24.2097

Freetrade Exchange, 37 Peter St, Manchester M2 5GB - Applications for Amendments to Roof Plant

Planning Permission and Listed Building Consent

Image 1: Clipped plan of roof.

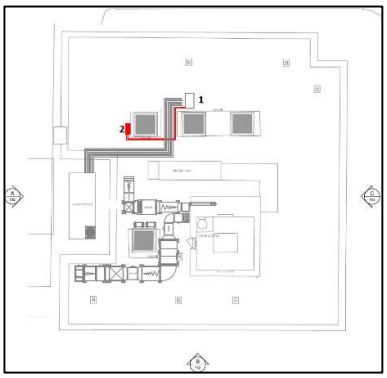
The slight relocation of the proposed unit is necessary for operational reasons. The piece of proposed plant will now be located slightly to the south and west of the approved location. The approved location is '1' on the plan below whilst the plant will now be located at location '2':

In heritage terms, our view is also that the unit has been installed is in a less sensitive / visible location than approved. It is set further back from the northern edge of the building and towards the western edge which abuts the gable of the adjacent office building. It will now benefit from being behind the plant screen to the northern perimeter which it did not previously, and generally is more screened by existing roof installations.

With regards to noise, the unit is at a greater distance from the most sensitive receptors and has not adversely affected the outcome of the original acoustic assessment in that the change is considered acoustically beneficial. A separate application will be submitted to discharge Condition 3b – plant acoustic verification of Planning Permission 142151/FO/2025 in due course.
